Determination 2019/028

Regarding the code compliance of parapet and post details without metal cap flashings to membrane decks at 17 Melford Street, St Marys Bay, Auckland

This determination considers the compliance of parapet and post details without metal cap flashings to two membrane decks. The determination discusses the details and whether the building work complies with the Building Code in regard to Clause E2 External moisture.

Figure 1: Parapet Detail (not to scale)

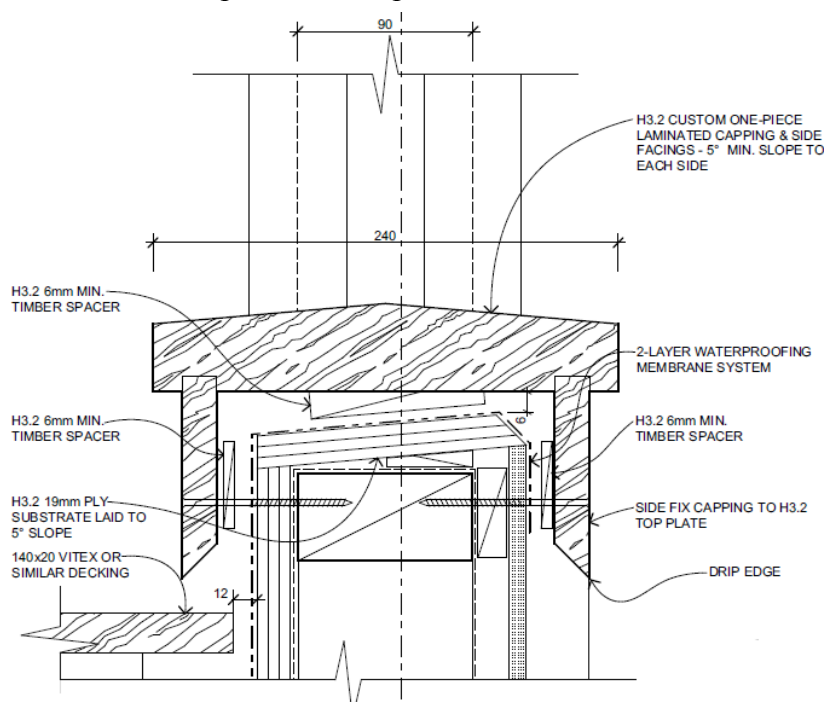
- Previous correspondence with the architect set out the authority’s reasoning for not accepting the detail as it is now presented without metal cap flashings.
- The metal flashings were critical in forming one of the defences to moisture penetration.
- Further design work is required to raise the level of detailing around the capping junctions with the posts and building corners.

- 4.2.3 The authority responded on 10 May 2019 and did not accept the determination. The authority submitted the following (in summary):
- The use of metal flashings was suggested as they have superior durability and long-standing life over membrane flashings. A stainless steel flashing will provide a minimum of 50 year durability rather than 15 years provided for by membrane flashings.

- 5.6.7 The proposed details differ from the Acceptable Solution in several respects. In particular, the minimum slope of the top of the parapet, the parapet flashing overlap of cladding, and the post protruding from the top of parapet.

- 5.6.10 The parapet detail deviates from the Acceptable Solution, at paragraph 6.5(a) “Tops of membrane cappings ... shall have a minimum slope of 10 degrees”. The proposed detail specifies the parapet top to have a slope of 5 degrees (refer Figure 1). I emphasise here that the Acceptable Solution is one way to satisfy the mandatory performance requirements of Clause E2 but not the only way to comply. The relevant performance requirements require the proposed detail to shed moisture away from junctions and prevent the penetration, accumulation and transfer of moisture. This performance is required not only of the parapet, but also the torch-on membrane as the weathertightness system of the decks which are also roofs.

- 5.6.11 The Acceptable Solution permits membrane decks to have a minimum slope of 1.5 degrees and membrane roofs to have a minimum slope of 2 degrees¹⁹; in this case the decks are sloped at 2 degrees. In this case, I consider the parapet slope, in combination with the timber capping being designed with spacers to allow drainage will result in the parapet being able to shed moisture, and on this basis I am satisfied that the proposed parapet details, with a 5 degree slope, will shed moisture.

- 5.6.12 The Acceptable Solution, at paragraph 6.5(b), requires the membrane capping to overlap the cladding. The details proposed by the architect show the membrane cappings to overlap the cladding. It is not clear from the proposed details as to the exact dimension of the overlap, however there is still an overlap, which from scaled drawings appear to be approximately 50mm. I consider the requirement is to ensure the completeness of the weathertightness envelope and that the envelope sufficiently covers junctions. In this instance, and taking into account the additional timber

- 5.6.15 In conclusion, the proposed parapet detail is comparable with the Acceptable Solution. The parapets are protected by a heat-fused torch-on membrane which provides the primary defence from moisture entry. In addition to this the timber capping provides a layer of defence to weathering and damage, and the fixing of the capping (with a timber spacer) allows for drainage and drying. Therefore the features of the detail considered as a whole shed water and prevent the penetration and accumulation of water to provide a robust defence system. Accordingly, I am satisfied that the proposed parapet design satisfies the relevant performance requirements of Clause E2.

Figure 2: Post Detail (not to scale)

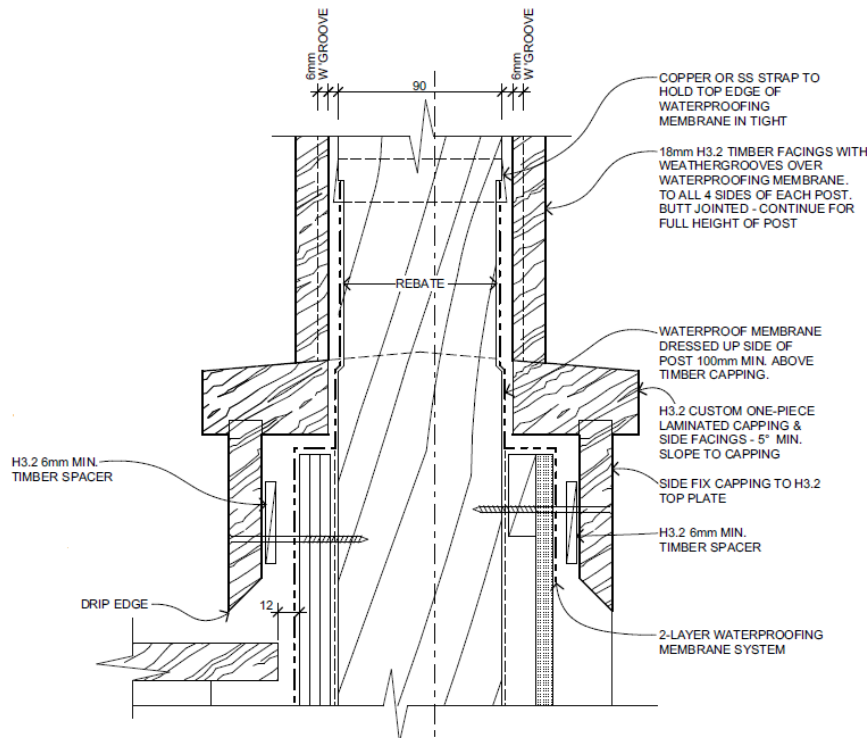
“Please review the B2⁷ requirement for the barrier to prevent moisture ingress. Irrespective of paint, timber treatment, or membrane upstand, the moisture will seep through resulting [in] it getting trapped. This would compromise the structural fixings and post’s structural strength. Please provide a solution to mitigate this”.

- 5.6.17 However, the post detail also deviates from the Acceptable Solution where the post protrudes from the top of the parapet structure, as opposed to being face-fixed to the outside of the cladding. The Acceptable Solution, at paragraph 8.5.9.1, comments that the fixing of posts into a membrane “is particularly risky, and should be avoided”. Therefore, care should be given to the design of the detail to minimise associated risk. It appears the detail in this instance has been thought through with care and the architect has described how the details will have sufficient defence to moisture ingress.

- 5.6.18 In addition to generally sharing the same materials and characteristics as the parapet detail, which I am satisfied complies with the relevant performance requirements of Clause E2, the post itself will also be wholly enclosed by treated and painted timber facings installed around and over the top of the post. The facings provide a rain screen or first line of defence to prevent the penetration water and allow for deflection of water away from the junction. The facings also have weathergrooves to

- 5.6.19 While the Acceptable Solution considers the post detail to be risky, I have considered the design details and discussed the relevant authoritative sources above. Mitigating factors in assessing its risk include: the degree of deflection provided by timber facings and timber capping to the top of the post, that weathergrooves will manage the movement of water if it penetrates the first defence of the facings and timber capping, and the material characteristics including treatment of timber and the paint system. Accordingly I conclude the post detail meets the relevant performance requirements of Clause E2.
